QUEENSTOWN LAKES DISTRICT COUNCIL
PLAN CHANGE HEARING COMMITTEE
REPORT FOR PLAN CHANGE 25: KINGSTON VILLAGE SPECIAL ZONE

REPORT DATED: 20 AUGUST 2009

**SUBMITTED BY: RALPH HENDERSON, SENIOR POLICY ANALYST,
QUEENSTOWN LAKES DISTRICT COUNCIL**

Figure 3: Plan Change Site⁸

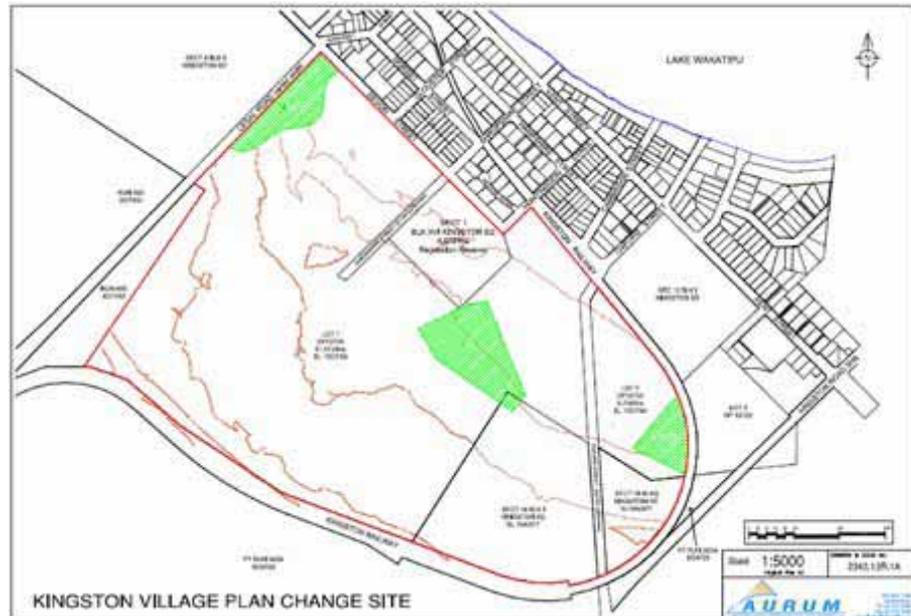
As shown on the Figure 3 below, Devon Street is located outside the plan change area. The submitters are not seeking that Devon Street be included within the

plan change, but rather that a separate process be initiated to stop the paper road and designate it as reserve for use as part of the golf course.

As a consequence, it is considered that this submission is outside the scope of the plan change, although it is within the ambit of the Commission hearing the plan change to recommend to Council that the initiation of the road stopping be investigated. The procedures for stopping roads are embodied in the tenth schedule of the Local Government Act 1974 which requires Council to provide reasons for stopping the road. Maintaining the potential for future public access through this area would be a likely requirement before stopping of the road would be considered appropriate.

1. The submission is outside the scope of the plan change.
2. Retaining the paper road enables this land to continue to be used as open space while retaining the potential for enhanced public access in the future. However as noted above, the Commission could recommend Council investigate the closure of Devon Street if it is deemed appropriate.

Figure 4: Areas identified in relation to ORC submission on natural hazards

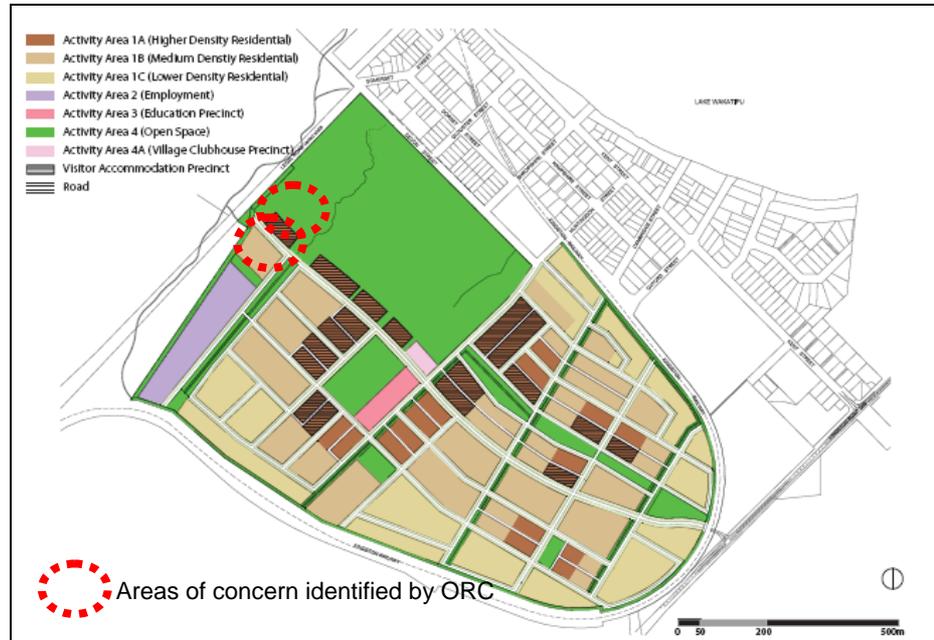
The western most extent of the plan change area has been identified as being subject to a natural hazard from rock fall run out from the steep mountain slopes above. **Otago Regional Council** [25/ 10/ 1] identify concerns regarding the location of areas of medium density residential (Activity Area 1B) and higher density residential with a visitor accommodation precinct (Activity Area 1A) adjacent to the northern end of the proposed deflector bund intended to protect against rock fall/ debris flow type hazards (Figure 4 below). Concerns identified by the Otago Regional Council include the shorter run out zones between the areas of potential rock fall and the northern areas of the proposed deflector bund and the lack of an identified setback from the deflector bund in the two areas identified. This is identified as a low probability high consequence hazard. The assessment of geotechnical hazards as part of the plan

change identified the risk recognised of rock fall or debris flow affecting the site as 'unlikely' to 'rare', although acknowledging should such an event occur the consequences to buildings would be 'medium' to 'major', but to people would be 'catastrophic'.²⁶ The relief sought by the Regional Council is the replacement of the proposed activity areas with Activity Area 2 (Employment), or that the Council be satisfied that the design standards and specifications of the proposed mitigation measures and that a similar level of setback from the deflector bund be applied to these areas as is applied to Activity Area 2 (Employment).

Kingston Village Limited (25/ 10/ 1) oppose in part the relief sought by the Otago Regional Council. An assessment of potential hazards accompanies the Section 32 Report to the plan change.²⁷ A supplementary report was also sought from Aurecon on the specific matters raised in this submission and options to achieve the relief sought.²⁸ This report specified a number of measures to reduce the probability of an event occurring and further reduce the consequence of any hazard event to protect residential development in these areas. These measures would be further refined through the detailed design and specification process at the consent stage. These measures include:
